Record of Decision Amendment

Operable Unit 2 (Deposit DD), Operable Unit 3, Operable Unit 4,
and Operable Unit 5 (River Mouth)

Lower Fox River and Green Bay Superfund Site

June 2007

Figure 1: Water Temperatures of the Namekagon River (USGS 2006)

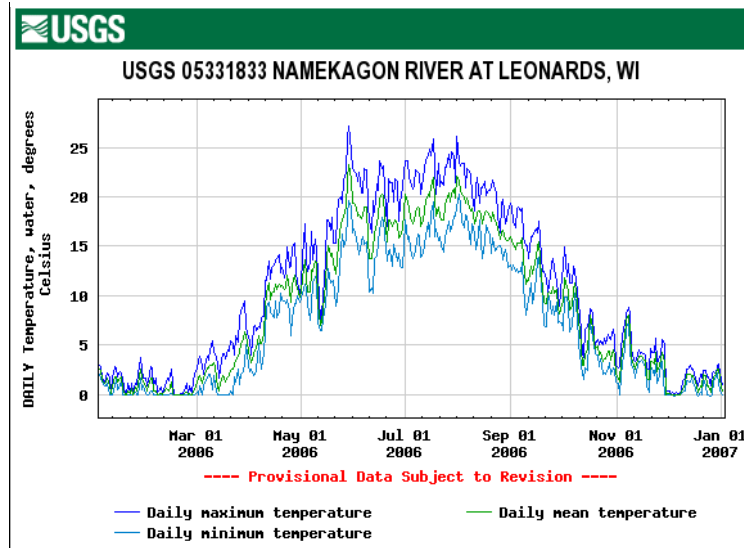
A review of the historical data shows that the analysis performed by Ashton on ice formation (2005) is cursory and incomplete. None of the conclusions are statistically verified, and fail to account for more extreme freezing events. The coldest temperature considered in the analysis is -5° F, while record lows of -20° and below have been recorded a number of times during the winter months. The analysis also does not investigate the effect of ice jams on additional ice formation in the areas behind the dam. It is unclear if such jams could result in ice impacting areas with caps.

The danger of ice scouring or attaching to caps is illustrated clearly in Ashton’s white paper by the passage “Occasionally anchor ice has been known to entrain the sediment to which it is attached into the flow when the ice releases from the bottom. The writer has seen small-fist-sized rocks in floating ice covers that undoubtedly were the result of such a process but when seen, these have been widely dispersed and represent only insignificant transport.” What Ashton doesn’t note is that cap integrity is unrelated to the amount of sediment transported in this fashion. Fist sized holes in caps compromise both their ability to contain sediments and also the ability to resist future scouring events.

The Agency agrees with the technical concerns for the impact of ice jams and/or frazil ice on locations chosen for capping in the Amended Remedy (ice jam potential discussed above). In Attachment D to Appendix D of the BODR in a report entitled, "Effects of Ice on Sediments in Fox River Near Green Bay, Wisconsin," by George D. Ashton, Ph.D., July 10, 2005, it was concluded frazil or anchor ice formation could form in the 1 ½ miles of river in OU3 below the Kaukauna Dam, and the first 1400 feet of river below the De

Figure 2: Flash Flood Data for Green Bay, WI (National Weather Service, 2006)

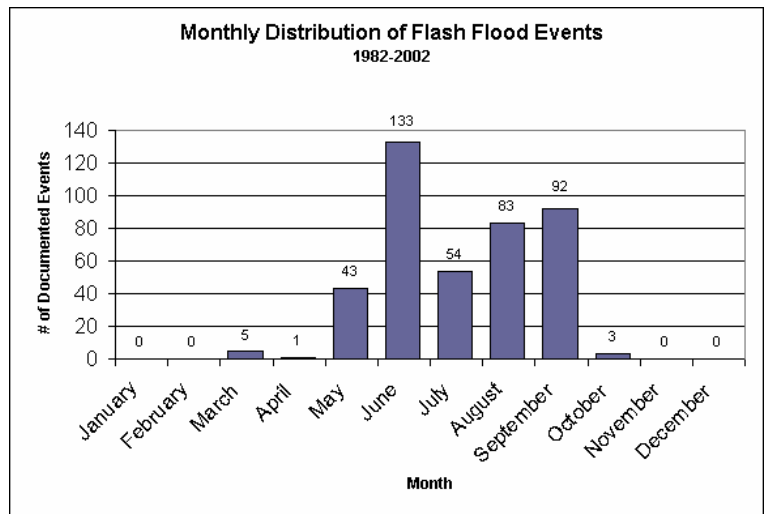
Flooding is also a significant threat to caps in the Fox River. As shown in Figure 2, significant precipitation events and therefore discharges in the Fox River over the past 20 years occur mainly from May to September, with the greatest number of previous flash flood events recorded in June (NWS). The largest recorded discharge (33,800 cfs) recorded at the mouth of the river also occurred in June over sixteen years ago. Data were obtained from the USGS water database, which is available on the internet at <http://waterdata.usgs.gov/nwis/sw>. Attempting to determine average discharges at the mouth of the river from USGS data is difficult as the agency appears to only take data from this station sporadically.

Data have been collected more regularly from a station in Wrightstown which has recorded 2 events approaching the 100 year flood estimate of 24,200 cfs used in the BODR (USGS). The station is located at the Rapid Croche Dam, which according to the USGS may influence discharges because of flow restrictions and other dam related activities. However, according to Figure 1-1 of the BODR this location is approximately 22 miles from the mouth of the river (Shaw, 2006). The two events in 1952 and 1960 had discharge rates of 24,000 and 23,600 cfs respectively. Locations downriver have experienced even greater discharges. One instance in 1990 caused a discharge of 33,800 cfs, and the same event caused a flow rate of over 46,000 cfs at the mouth of the East River as it flows into the Fox River (Baumgart, 2007, see attached figure). These high flow rates were caused by a combination of heavy rains and a powerful seiche. A seiche occurs when strong northwesterly winds build up water in the bay, which alters water levels and flow rates. The above data indicate that flood events of the calculated 100 year flood magnitude occur much more frequently than estimated, and wind can play a role in these events.

Figure 3: Frequency of Storm Related Wind Events in Green Bay, WI. (National Weather Service, 2006)

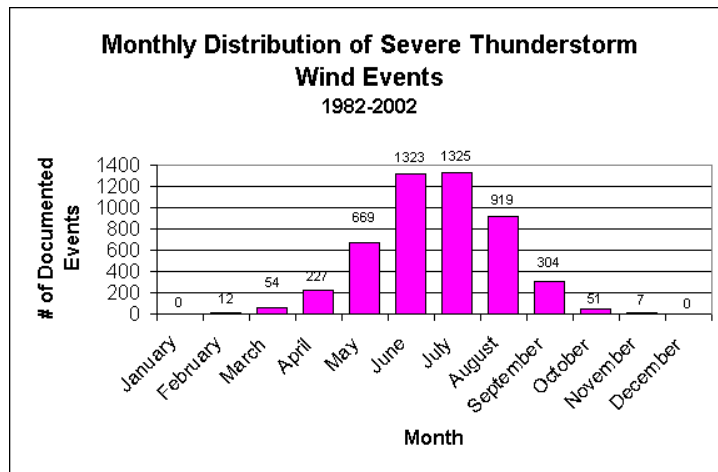
Other weather related events could have an indirect impact on caps within the Fox River. High wind events on waterways can lead to accidents or unplanned occurrences such as ships breaking their moorings and running aground in shallow areas. Institutional controls are of no use in these situations, so they must be planned for accordingly. Severe weather wind events occur primarily in the summer months, with a similar temporal distribution as flood events (Figure 3). While wind events are unlikely to have the same impact as flooding or ice formation/jams, they should still be considered when evaluating suitability of a site for a cap.

The above data indicate that caps in the Fox River have a high risk of being compromised by scour events 10 months out of the year. The potential for ice related scours is high though the winter months, and through the summer and early fall flood events become a significant concern. Placing a cap in such a high risk area is completely unacceptable.
